Product Change Notification (PCN)

PCN Number: PCN_UtRJ45LAN_20261105 Affected Series: WE-RJ45LAN Affected Part Number: see table "PART NUMBER, REVISION & DATASHEET" PCN Date: 2026-08-05 (YYYY-MM-DD) Effective Date: 2026-11-05 (YYYY-MM-DD)	Change Category: ☐ Equipment/Location ☒ General Data ☐ Material ☐ Process ☐ Product Design ☐ Shipping/Packaging ☐ Supplier ☐ Software
Contact: Product Management Phone: +49 (0) 7942 - 945 5001 Fax: +49 (0) 7942 - 945 5179 E-Mail: pcn.eisos@we-online.com	Datasheet Change: ☒ Yes ☐ No Attachment: ☐ Yes ☒ No

As a datasheet information amendment, Würth Elektronik eiSos will correct the recommended stencil design. This is a datasheet correction only. There will be no change in fit, form, function, quality or reliability of the product. The preliminary datasheets of the affected part numbers which are available in the online catalogue will be available on the website after the PCN date. Link to the website: [WE-RJ45LAN](#)

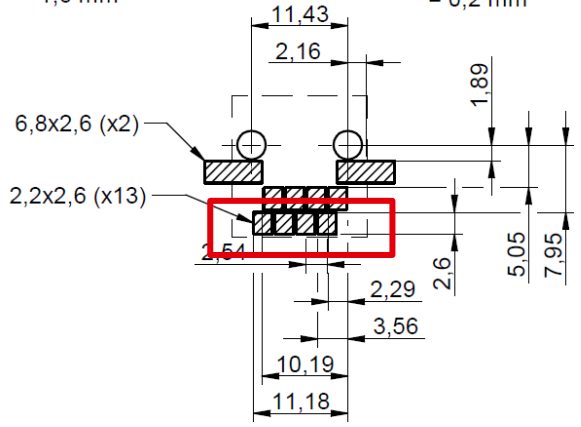
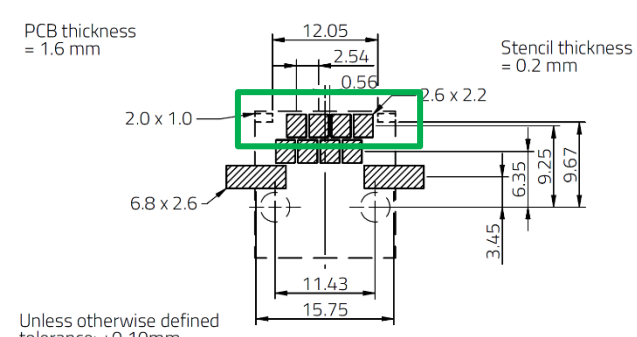
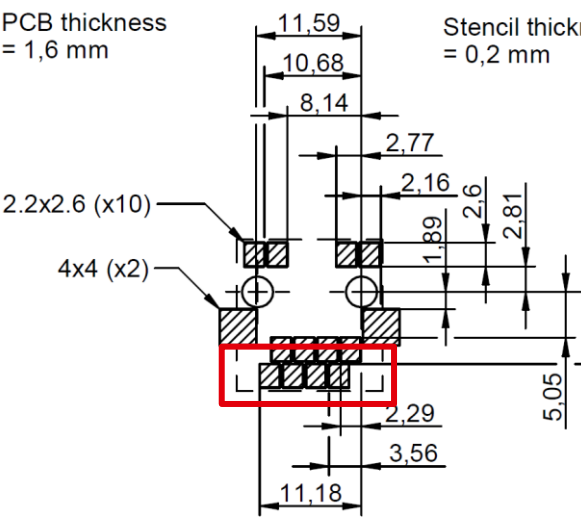
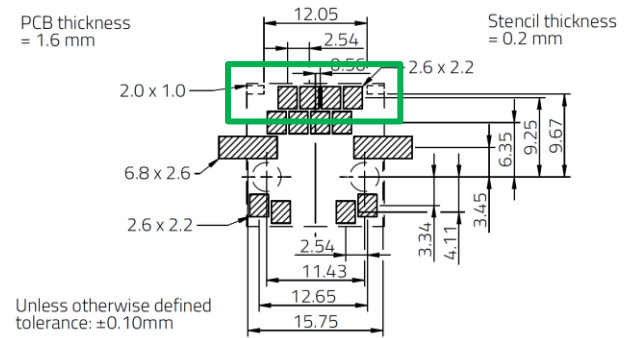
before change	after change
Without standoff	With standoff
74980100000	
PCB thickness = 1,6 mm Stencil thickness = 0,2 mm 	PCB thickness = 1.6 mm Stencil thickness = 0.2 mm  Unless otherwise defined tolerance: ±0.10mm
74980101200	
PCB thickness = 1,6 mm Stencil thickness = 0,2 mm 	PCB thickness = 1.6 mm Stencil thickness = 0.2 mm  Unless otherwise defined tolerance: ±0.10mm

74981102100

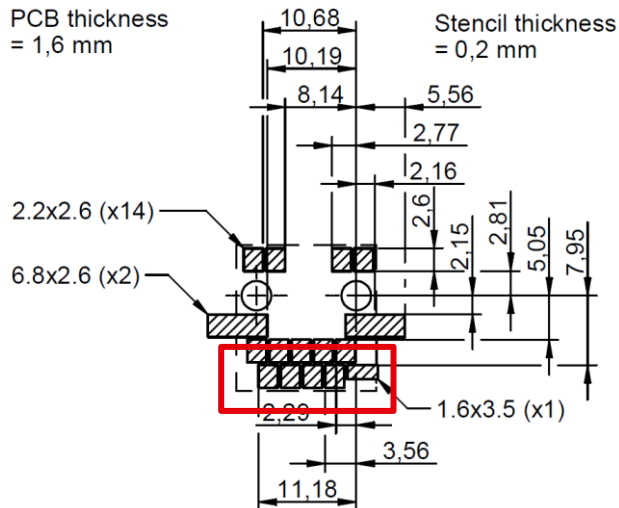
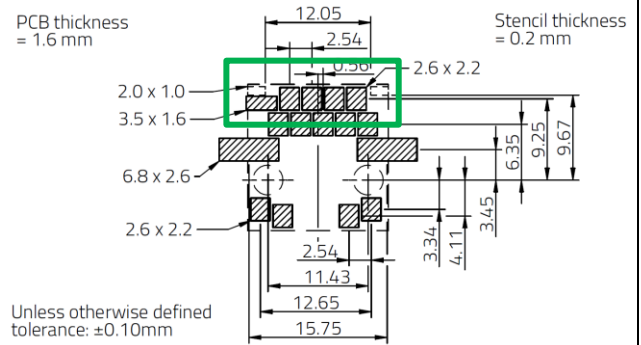
PCB thickness
 = 1,6 mm

PCB thickness
 = 1.6 mm

4981104402

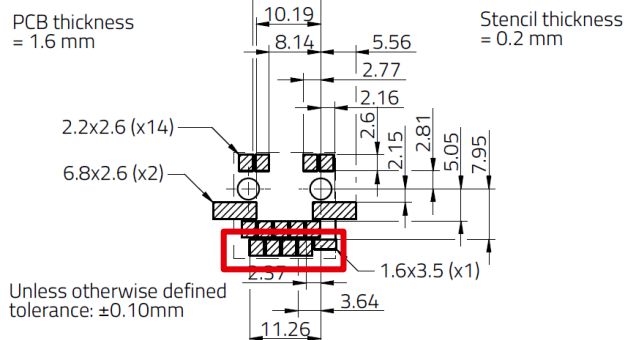
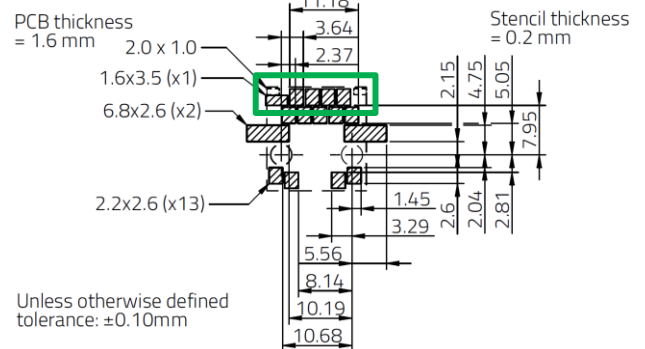
PCB thickness
 = 1.6 mm

PCB thickness
 = 1.6 mm

S22100221

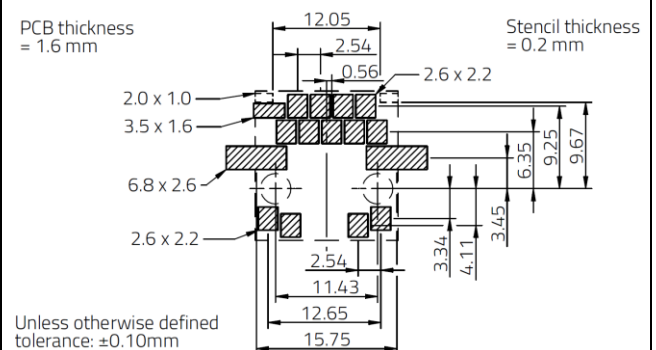
No stencil design until now
